Subject: CHECK ENGINE LIGHT ON WITH DTC P0300-P0304	Bulletin No: 01-014/16
	Last Issued: 09/22/2016

This bulletin supersedes the previously issued bulletin(s) listed below. The changes are noted below in Red beside the change bars.

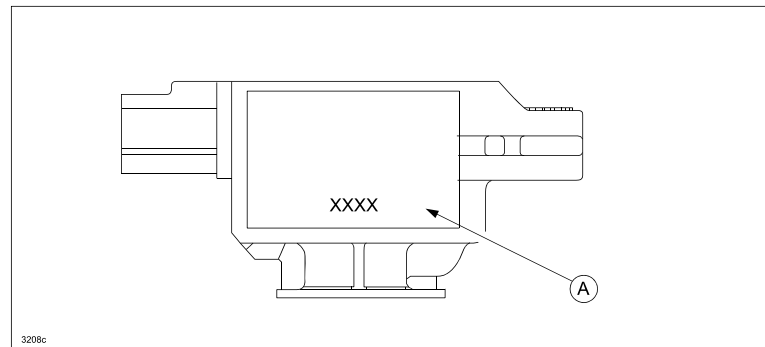
To distinguish between YUMEBISHI and MITSUBISHI ignition coils, look at their lot numbers (A). YUMEBISHI have 4 digit lot numbers and MITSUBISHI have 5 digit lot numbers as shown.

6	Year (4=2014, 5=2015, 6=2016)
3	Month (1=Jan, 2=Feb, 3=Mar...X=Oct, Y=Nov)
2	Day
8	
B	MITSUBISHI-produced only (A=Daytime, B=Nighttime)

NOTE: There is no part number change. Differentiate the new modified ignition coil (YUMEBISHI-produced) from the old one by the lot number on the ignition coil. Ignition coils with the lot number of 6328 (March 28, 2016 production) or higher are modified.
